OVERLAND RANCH PORCHVIEW PARK

SITE PLAN

OVERLAND RANCH PORCHVIEW PARK
SITE PLAN
AURORA, CO

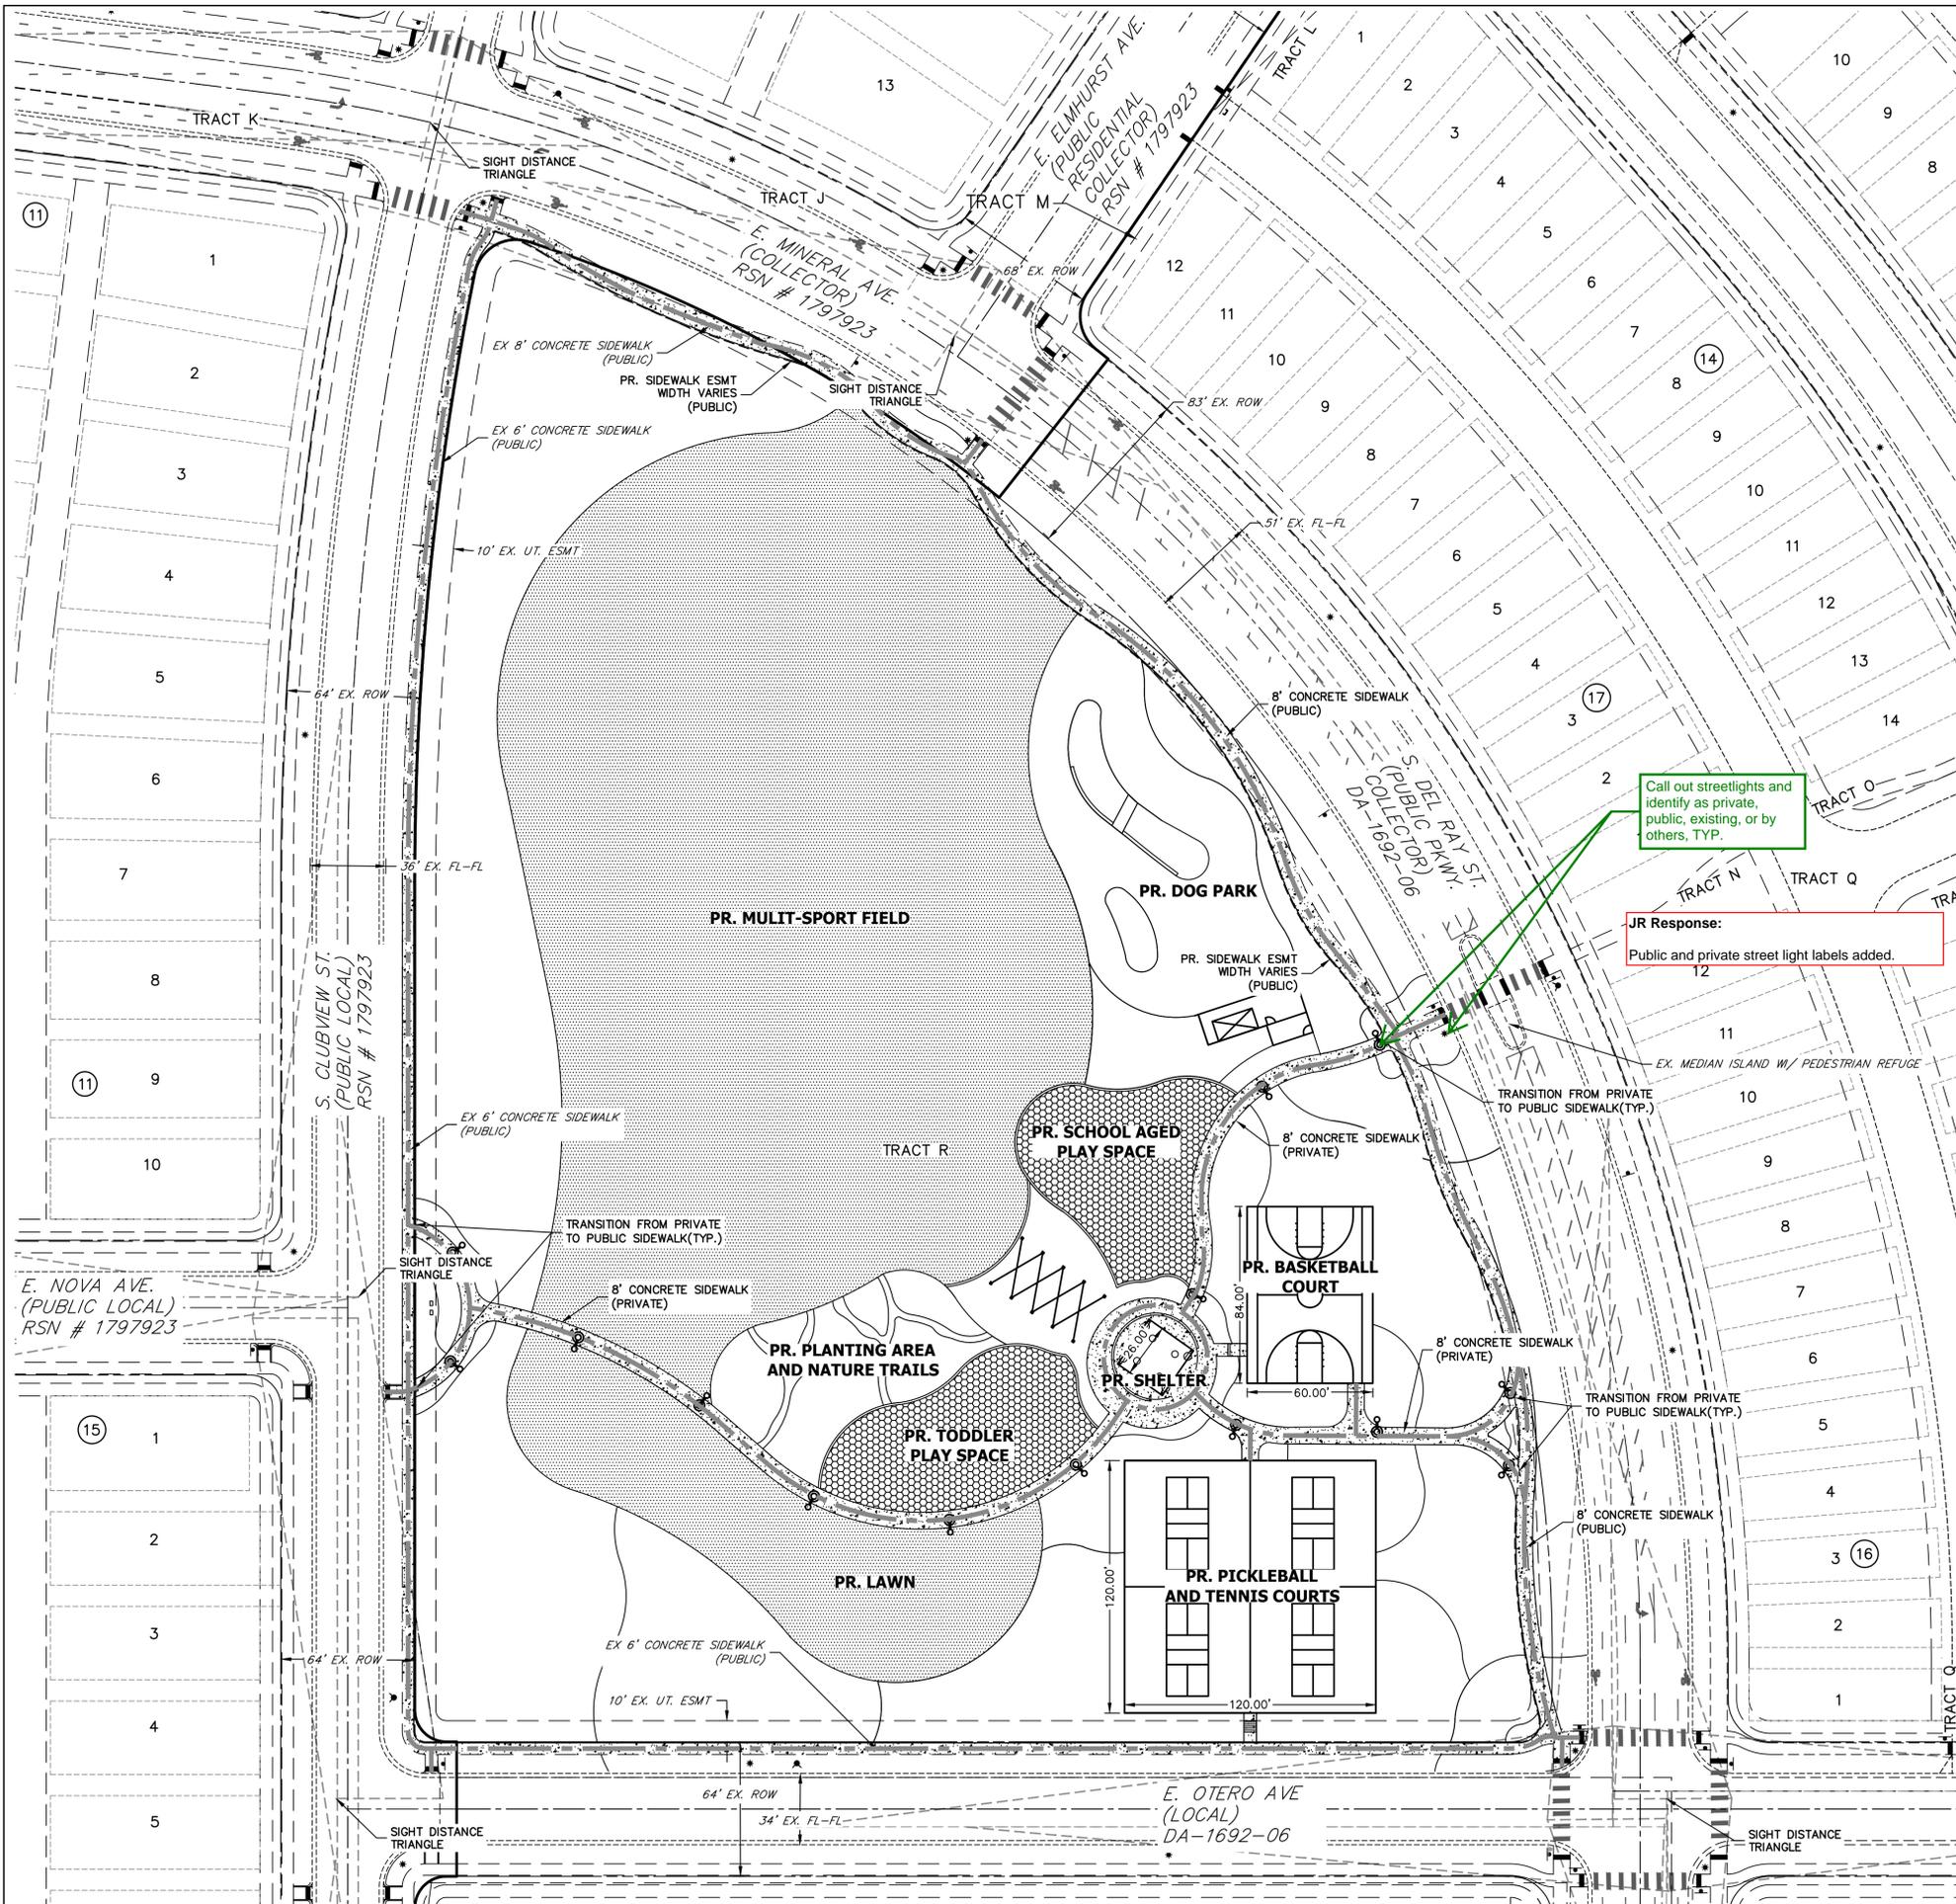
Call out streetlights and identify as private, public, existing, or by others, TYP.

JR Response:
Public and private street light labels added.

SHEET TITLE:
OVERALL UTILITY PLAN

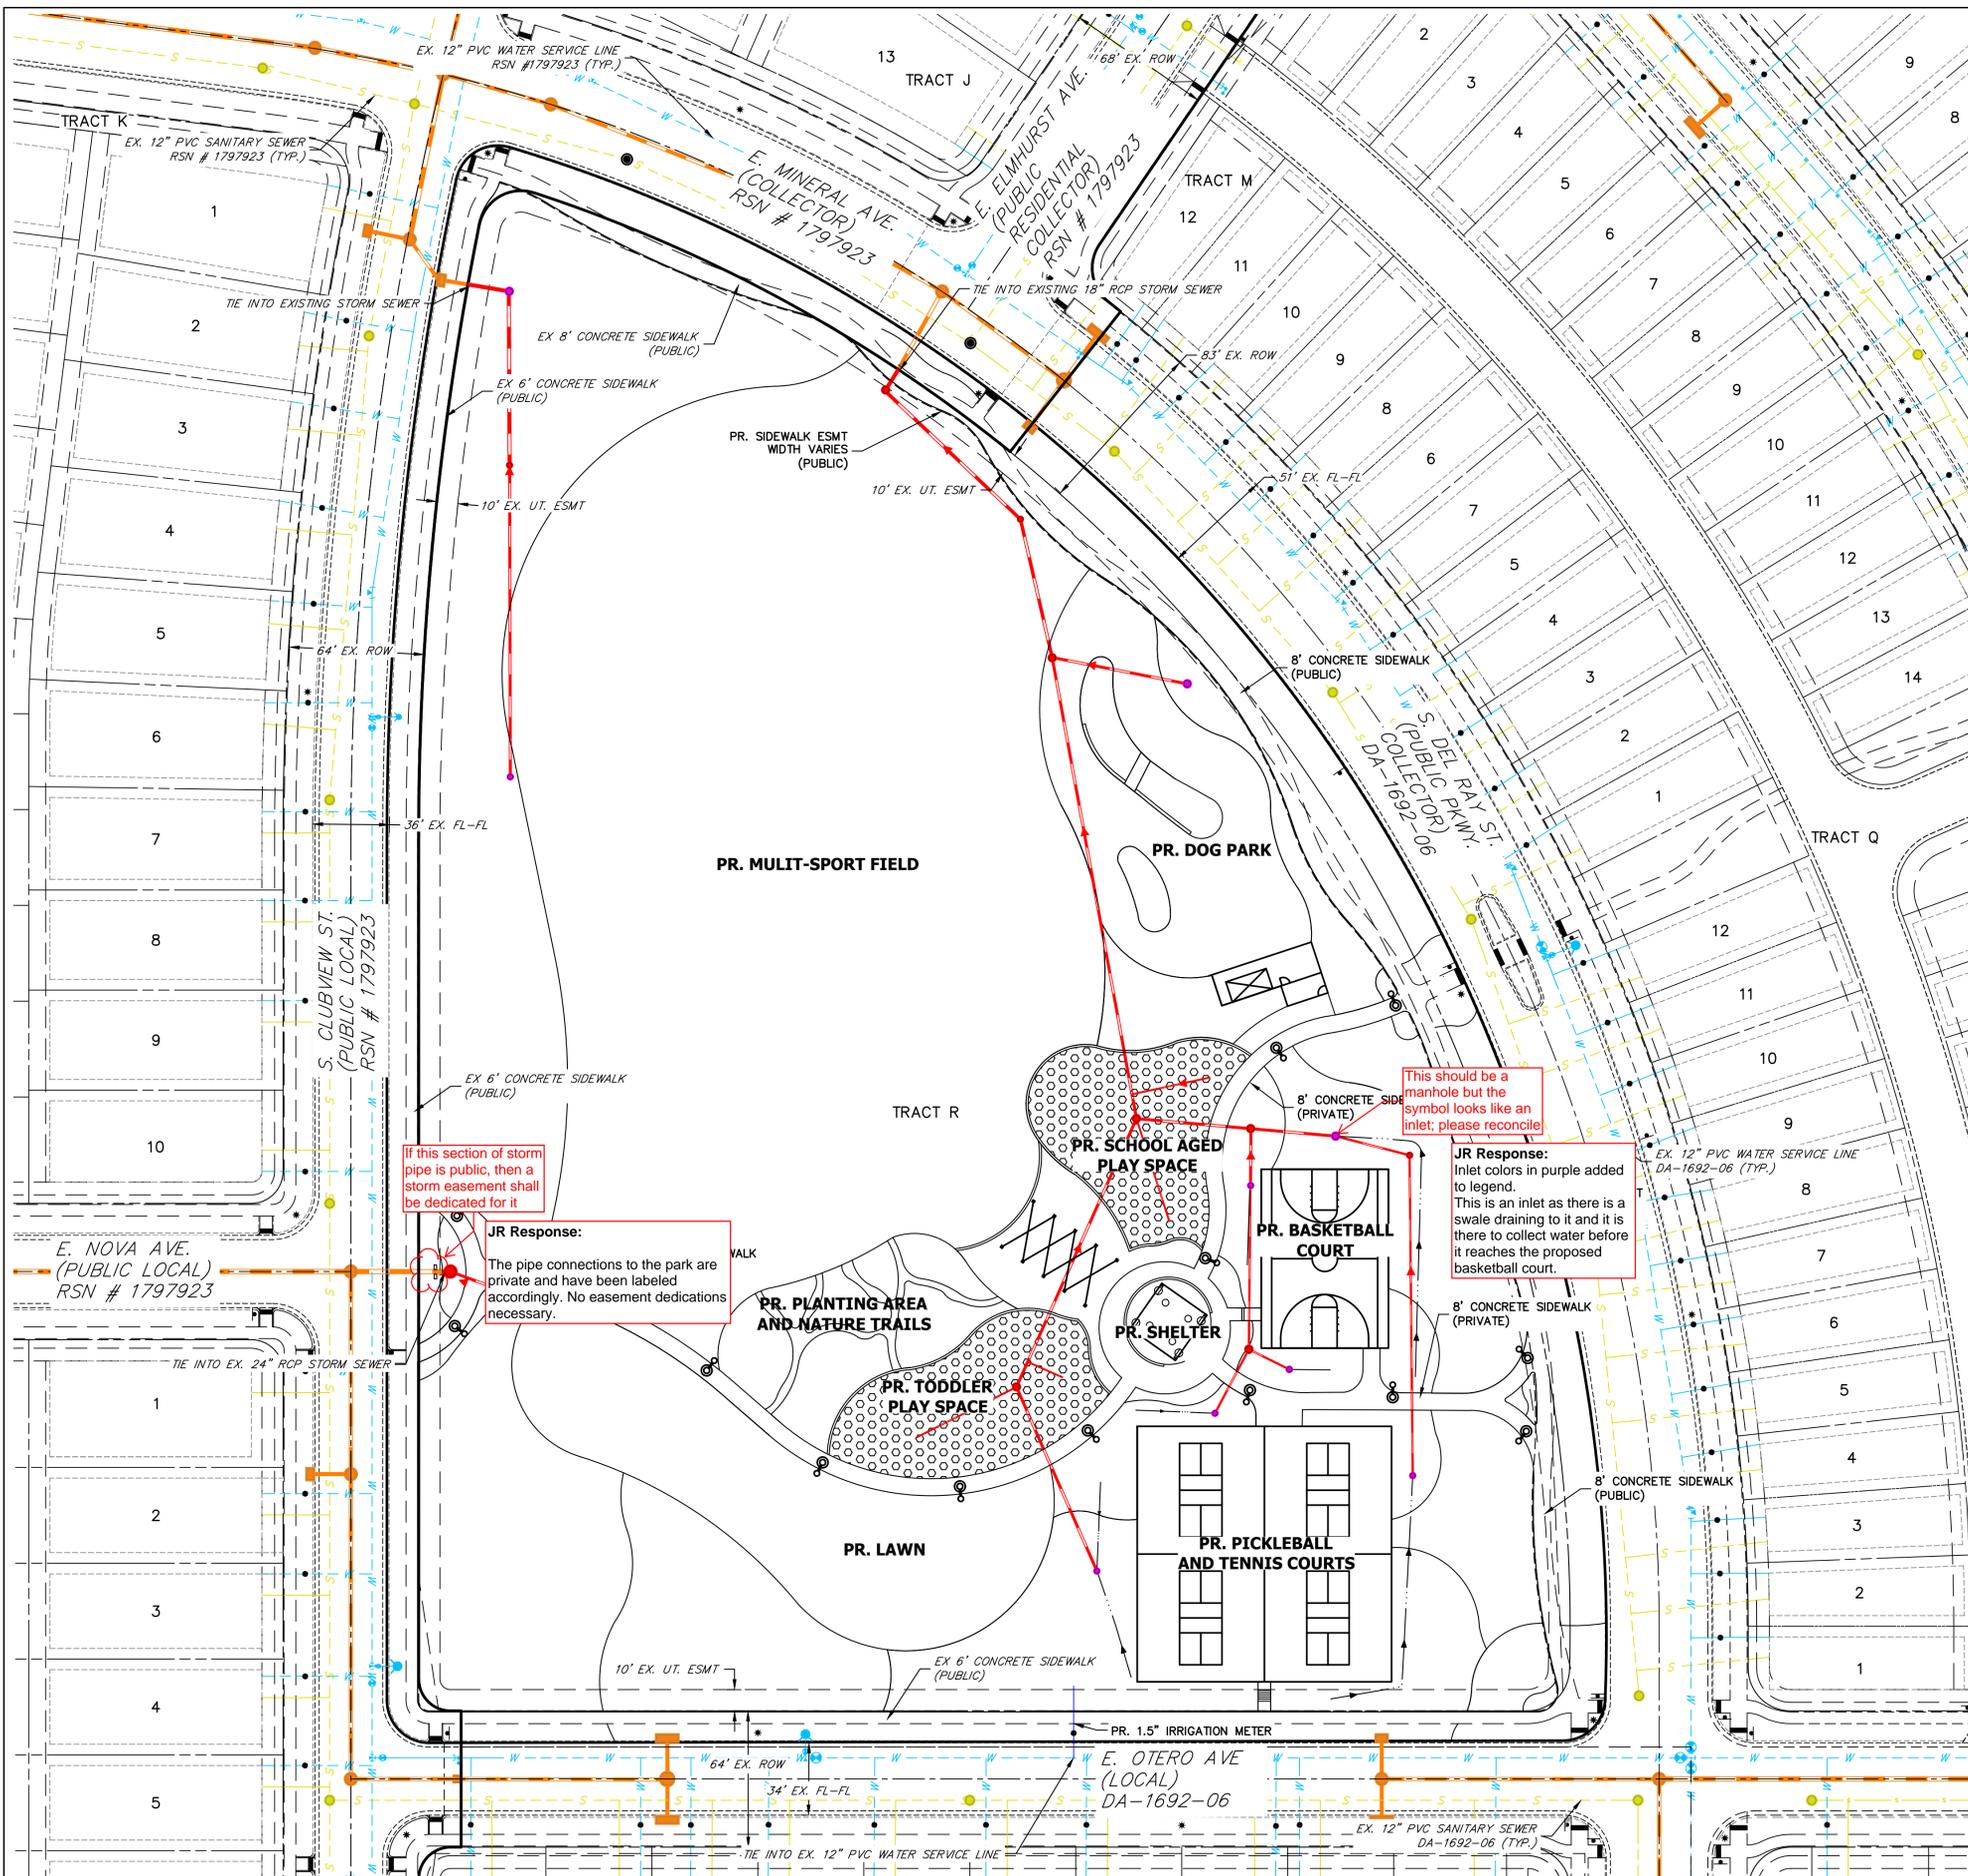
If this section of storm pipe is public, then a storm easement shall be dedicated for it

This should be a manhole but the symbol looks like an inlet; please reconcile

Provide the following note:
Water service lines are public up through the meter and are private downstream of the meter.

JR Response:
The pipe connections to the park are private and have been labeled accordingly. No easement dedications necessary.

JR Response:
Inlet colors in purple added to legend. This is an inlet as there is a swale draining to it and it is there to collect water before it reaches the proposed basketball court.

JR Response:
The following note was added to this page.

GRADING NOTES

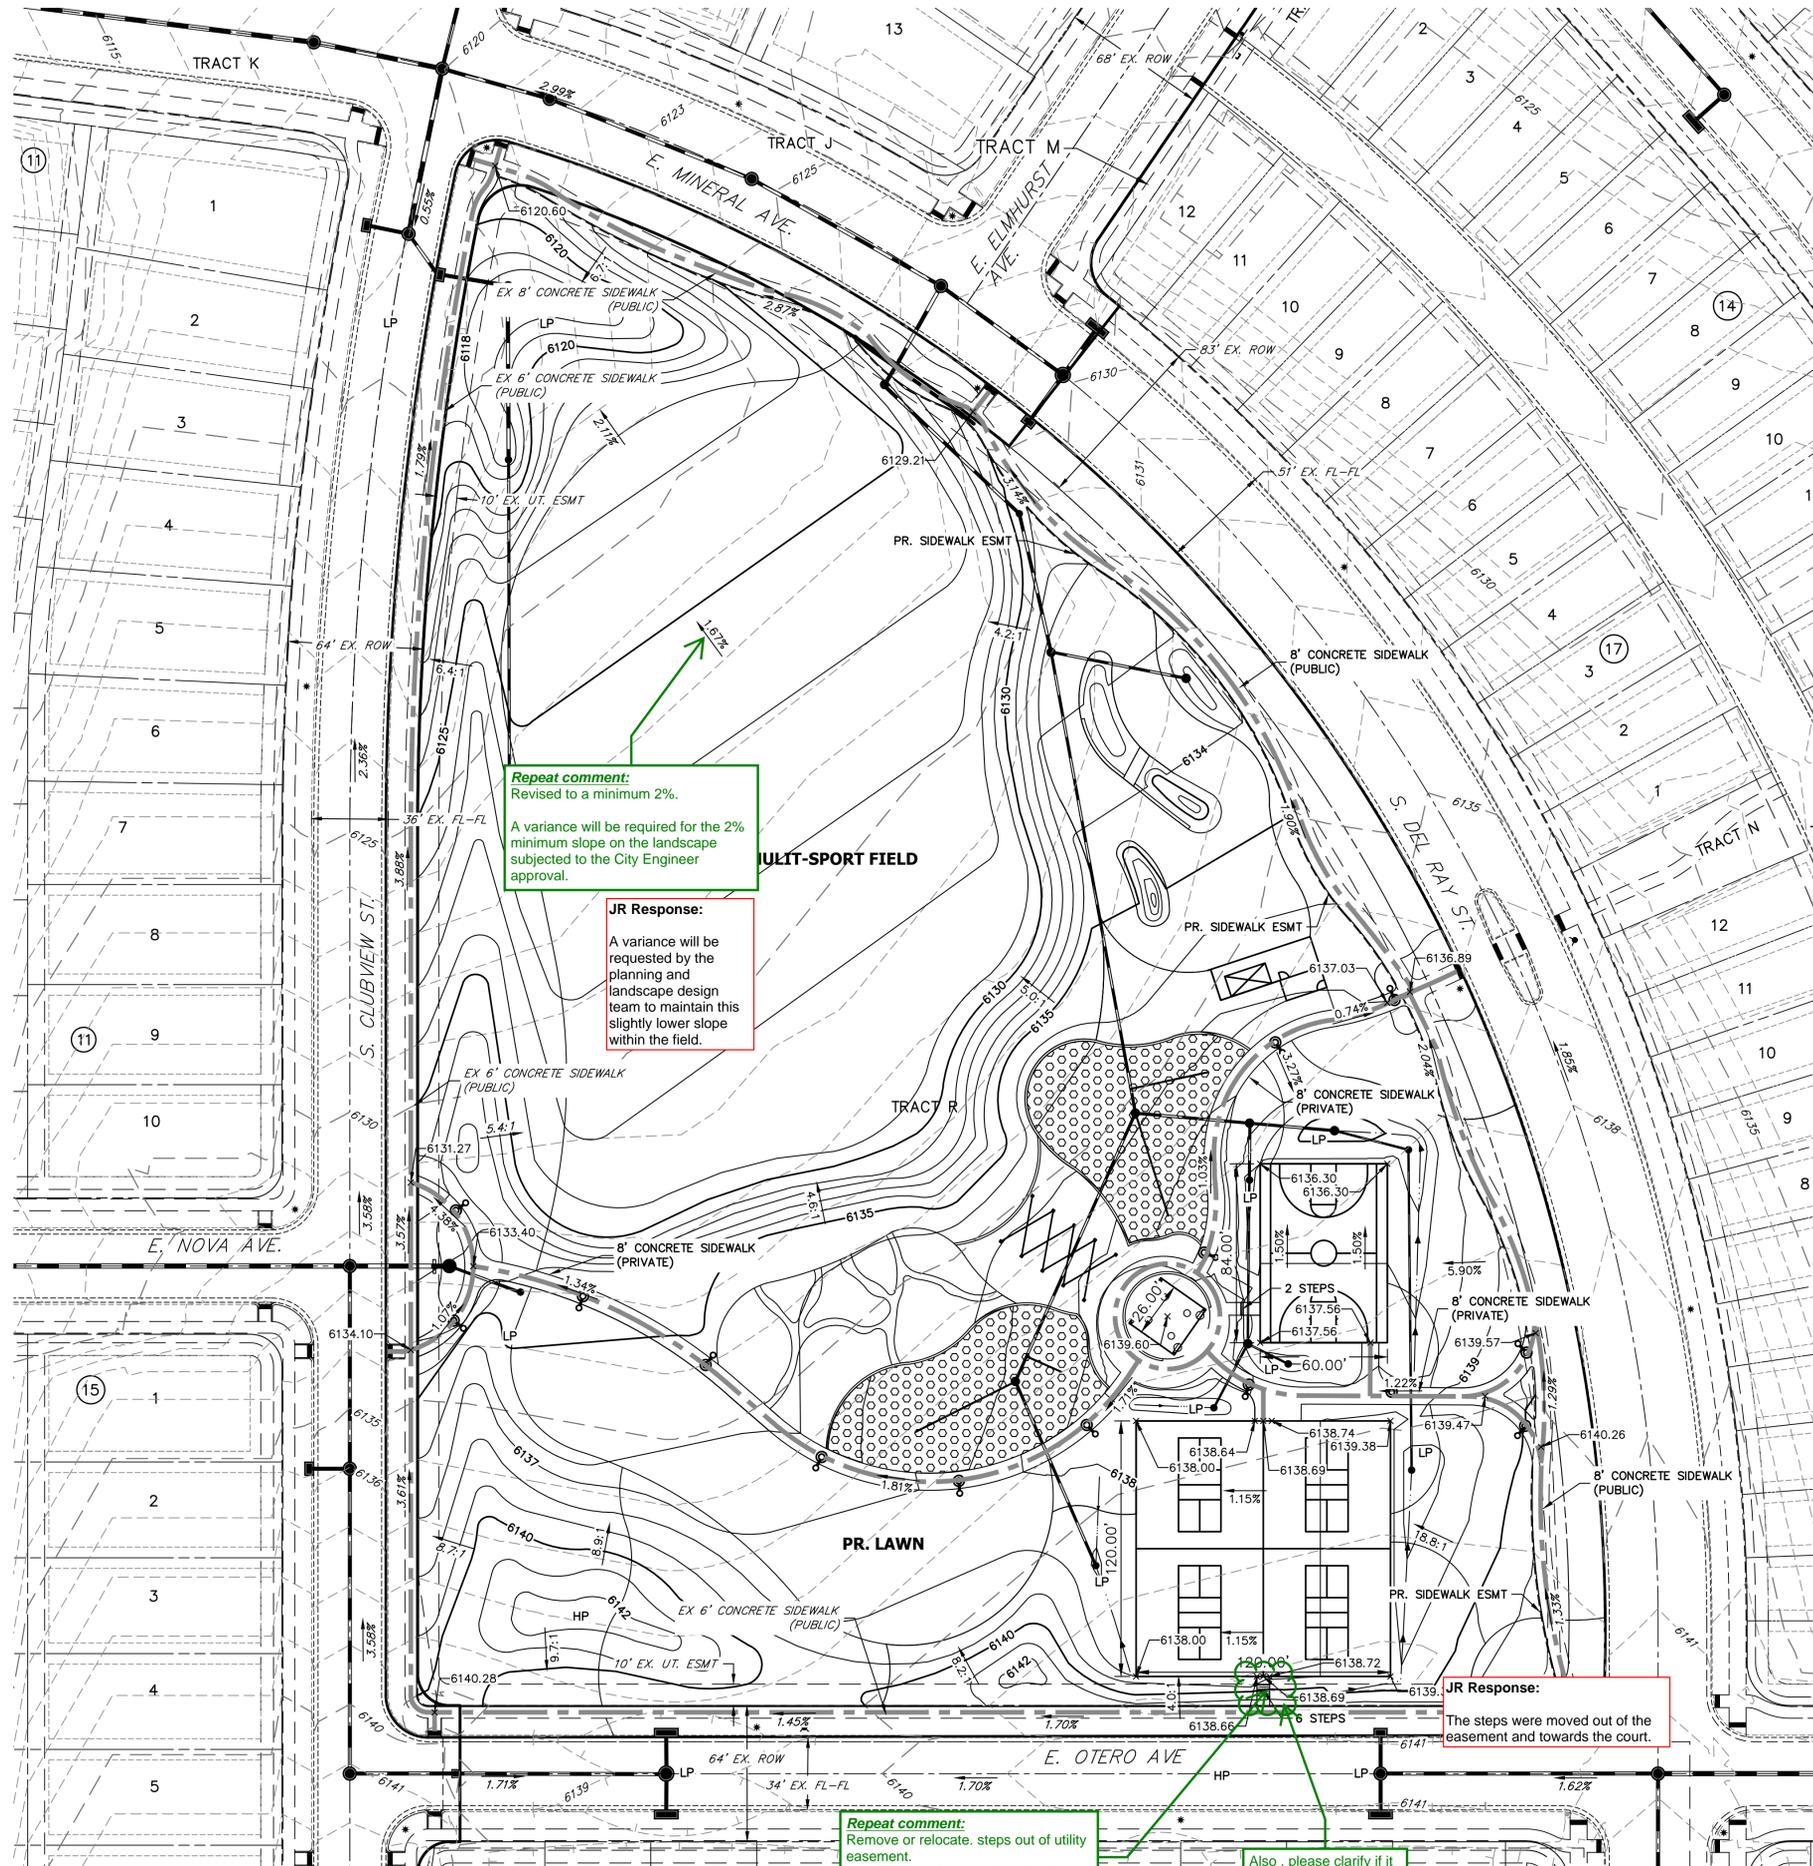
Repeat comment:
 Revised to a minimum 2%.
 A variance will be required for the 2% minimum slope on the landscape subjected to the City Engineer approval.

Repeat comment:
 Remove or relocate. steps out of utility easement. Can the steps be moved to the others sides of the court?

Also, please clarify if it is a staircase or steps

JR Response:
 A variance will be requested by the planning and landscape design team to maintain this slightly lower slope within the field.

JR Response:
 The steps were moved out of the easement and towards the court.

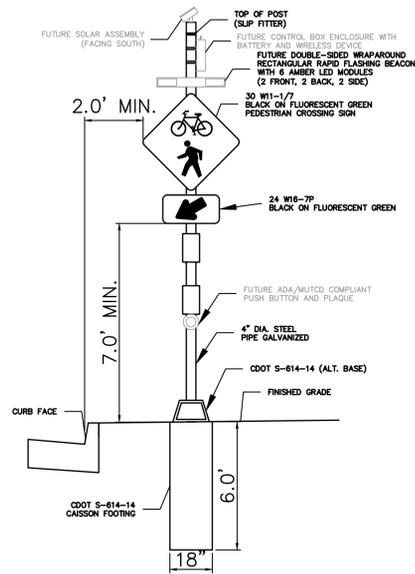
Note, these details are on Sht 7, update

Use Upper/Lower case font

Use updated MUTCD 21"x15"

JR Response:
 The details sheet number was updated.

JR Response:
 The sign was adjusted to include both upper and lower case font.

JR Response:
 The sign size was updated.
